6 October 2020

Rev 02

## ARCHITECTURAL STATEMENT IN RESPONSE TO COUNCIL'S CONCERNS REGARDING HEIGHT.

Figure 1 - Section through Building C

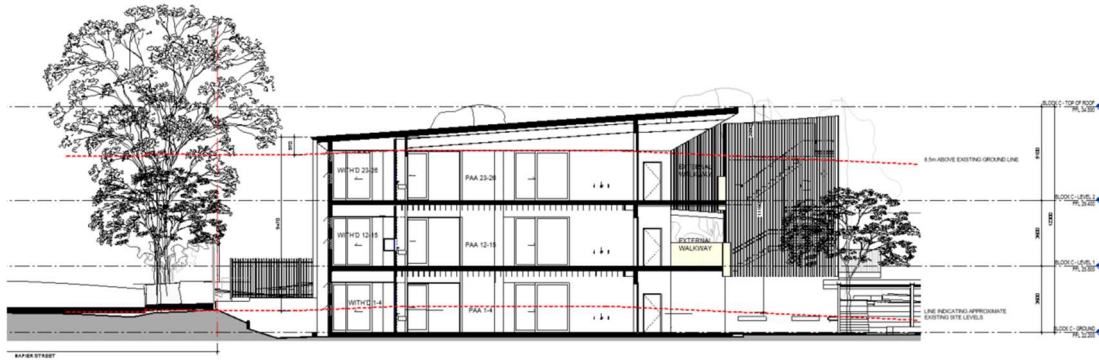
#### **Larger setbacks should be provided to Napier St to reduce bulk and scale**

The Educational Facilities and Standards Guidelines (EFSG) sets out the design requirements for new school infrastructure in NSW. The EFSG is based on data gathered from over 50 years of designing, operating and maintaining schools in NSW. It has been developed to ensure new schools and school upgrade projects provide flexible learning environments that align with current and emerging pedagogies, and respond to the needs of the school and local communities. The floor to floor height of 3.6m has been established as the minimum permissible under EFSG. 2.7m high ceilings are required to all learning spaces and an allowance of 900mm for structural concrete slabs and beams and air conditioning systems is the design minimum.

The EFSG sets a minimum roof pitch of 4 degrees to enable service installation and maintenance, accommodate 1:100 ARI events, and avoid future drainage issues. The roof pitch has been reduced to the minimum recommended under the EFSG and the gutter line has been directed to the street to reduce the bulk and scale to Napier Street. The pitching point has been established as the minimum required for structure and services to be installed to the ceiling spaces closest to Napier Street. To set the building back any further will significantly impact on the play space directly accessible to the

learning spaces of Building C. Taking into consideration the limited impacts of bulk and scale on solar access to the Napier Street properties we are of the opinion the current setbacks are appropriate.

Figure 4 – Landscape plan showing solid reinforced blockwork retaining wall and vehicle barrier balustrading

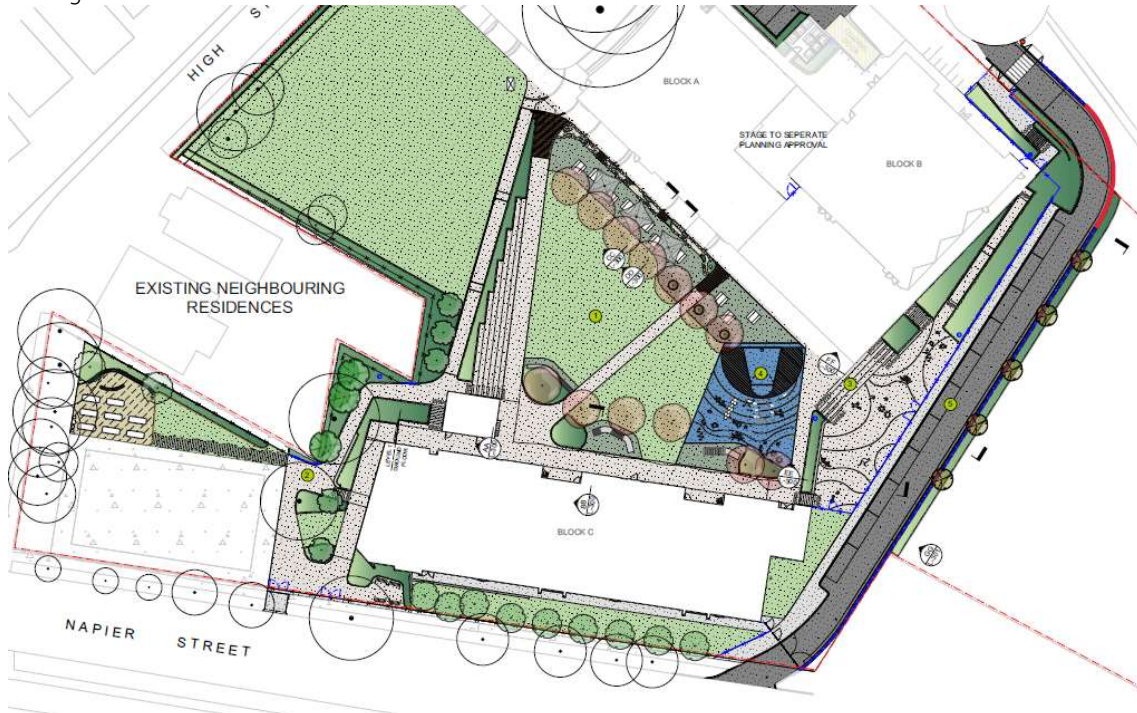
**The height, massing, and setbacks of the development should be reviewed to better relate to the topography and transition to the east to address its impacts.**

Further to the building changes, and with regards to Council's concerns about bulk and scale when viewed from Pat O'Connor Reserve, the new roadway will be suspended above the existing ground levels. The civil engineers have manipulated the embankment such that the drop off road is less than 600mm from existing ground level for the majority of its length, with the exception of the north east corner. In this location a reinforced concrete blockwork wall will be required to comply with AS2890.1.

The extent of the solid wall is highlighted in the image below in red, located on the northern part of the through road.

For child safety a vehicle barrier balustrade shall be installed to the majority of the bounding edge between the roadway and the reserve. Although this balustrading is see through, it is suspended above the existing ground and does provide visual barrier when viewed from the Cup and Saucer Creek. The intention is to landscape in front of this barrier to reduce its mass.
